City of El Paso – City Plan Commission Staff Report

Case No: SUSU15-00020 – Bailey Addition Replat C
Application Type: Resubdivision Combination
CPC Hearing Date: April 23, 2015
Staff Planner: Joaquin Rodriguez, (915) 212-1608
rodriguezjx3@elpasotexas.gov
Location: North of Vinton and East of Doniphan
Acreage: 22.3
Rep District: ETJ (Westside)
Existing Use: Vacant
Existing Zoning: N/A
Proposed Zoning: N/A
Nearest Park: Rio Grande River Trail #1 (.05 mi)
Nearest School: Canutillo Elementary (.5 mi)
Park Fees Required: \$109,600
Impact Fee Area: Westside
Property Owner: San Bencizio Properties
Applicant: San Bencizio Properties
Representative: Sitework Engineering

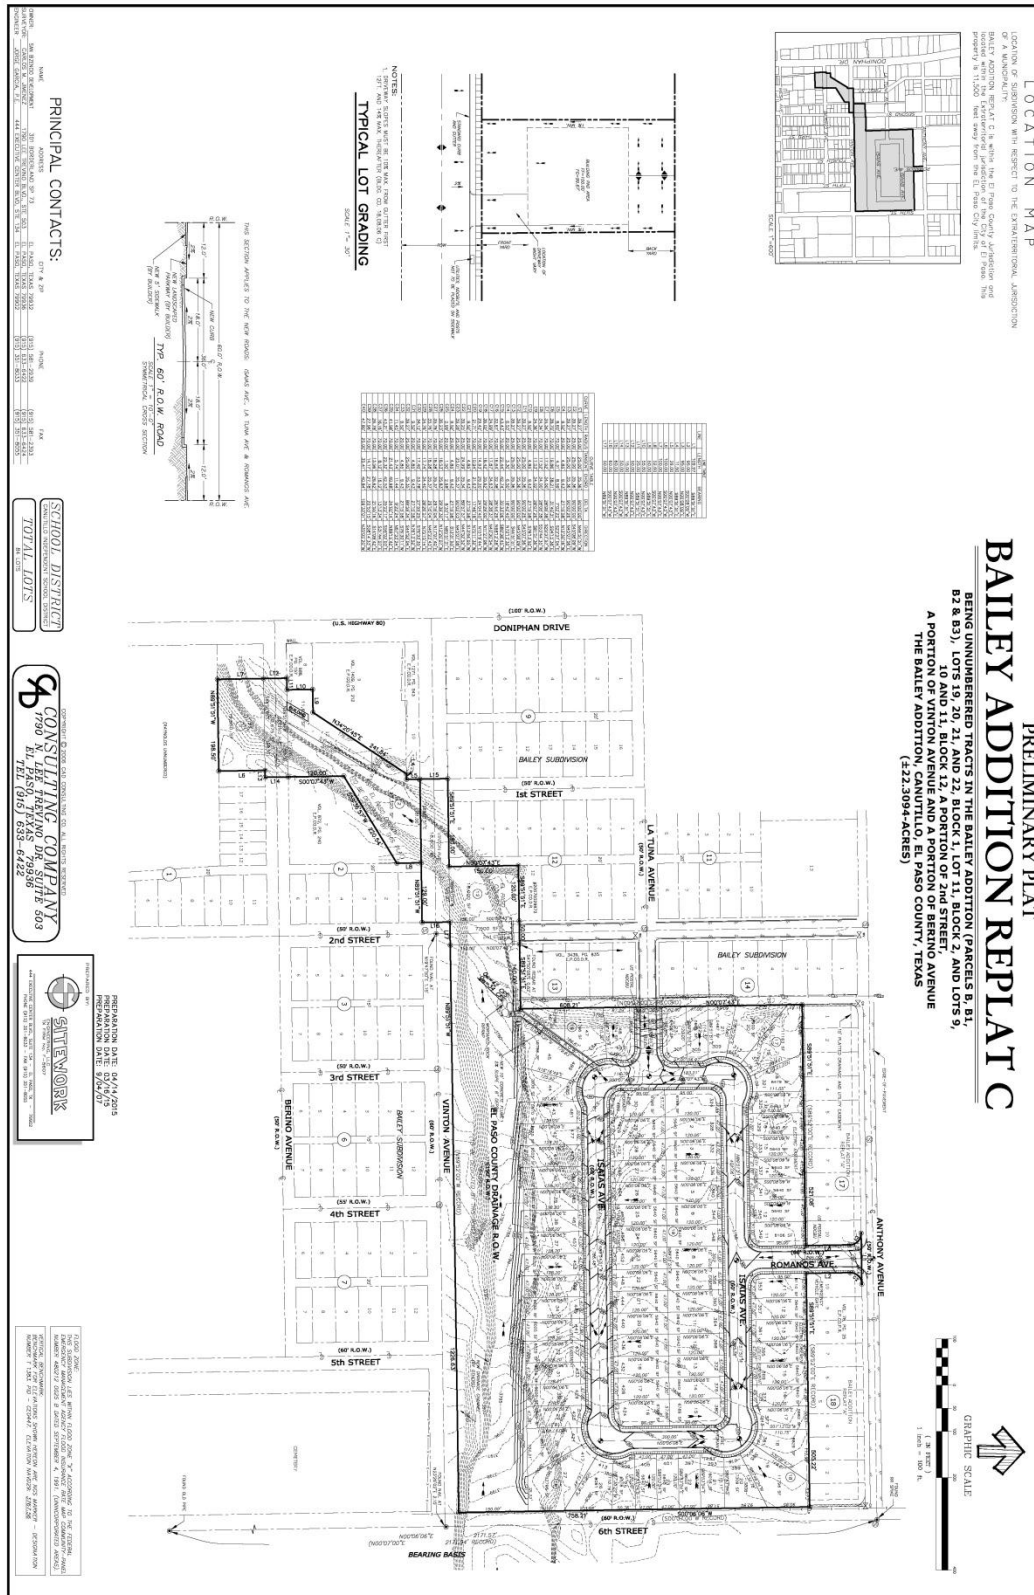
1. The EPWU has coordinated with the Owner/Developer the location of the site for a proposed lift station and the alignment of the associated force main. The plat needs to show:

- The lift station site as a separate lot.

- Easements required to accommodate the proposed force main thru the drainage right-of-way.
